From: HUBBARD, BRADLEY <bhubbard@usbr.gov>
Sent: Thursday, October 23, 2014 5:00 PM
To: Buckman, Carolyn; Veronese, Gina; Frances Mizuno
Subject: Fwd: Question regarding Long-Term Water Transfers Draft EIS-EIR

Re: Comments on the Long-Term Water Transfers Draft Environmental Impact Statement / Environmental Impact Report

Figure 1. Normalized Stream Depletion Curve. (from TNC 2014, normalized to the simulated amount pumped in one season.)

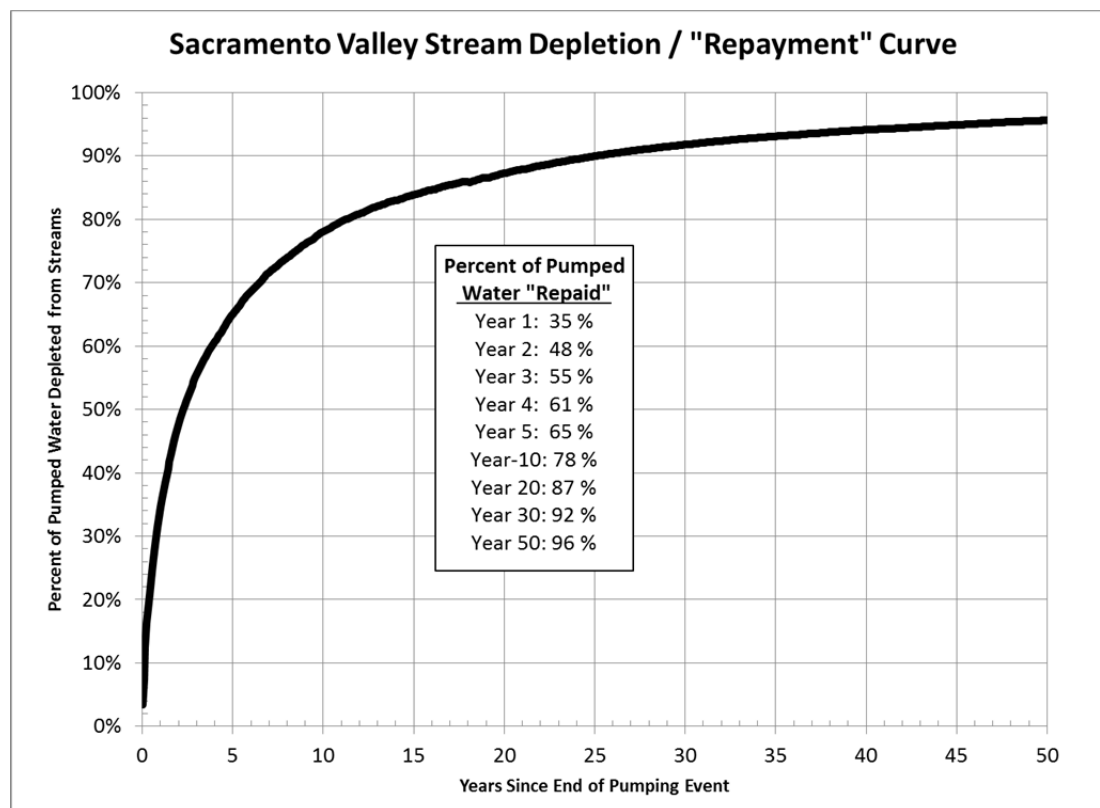
Simulations performed by TNC using DWR's C2VSim integrated ground and surface water model of the Central Valley indicate that groundwater pumping at scales similar to the Proposed Action affects a large area and, very importantly, that streamflow depletion from even a single year of such pumping persists for decades⁷. The timing of these impacts is illustrated in Figure 1, below.

Figure 1 shows that streamflow depletion is significant for many years after pumping has ceased, with only about 65 percent of ultimate stream depletion expressed even 5 years after pumping has stopped. It takes 25 years for the system to nearly fully "recover" (90 percent "depletion recovery"). Although different assumptions regarding well locations and depth will lead to differently shaped depletion curves, the best information available suggests that impacts from pumping will persist for decades for wells distributed over wide areas and depths, as is the case for the Proposed Action. In contrast, Figure 3.1-3 of the EIS/EIR does not reflect this full duration of impact, at least as expressed in percent changes in CVP and SWP exports. Please explain how the modeling done for this Draft EIS/EIR accounts for the compounding impacts to water supplies from multiple years of pumping, and how the duration of impact through full recovery will be accounted and mitigated under Mitigation Measure WS-1.
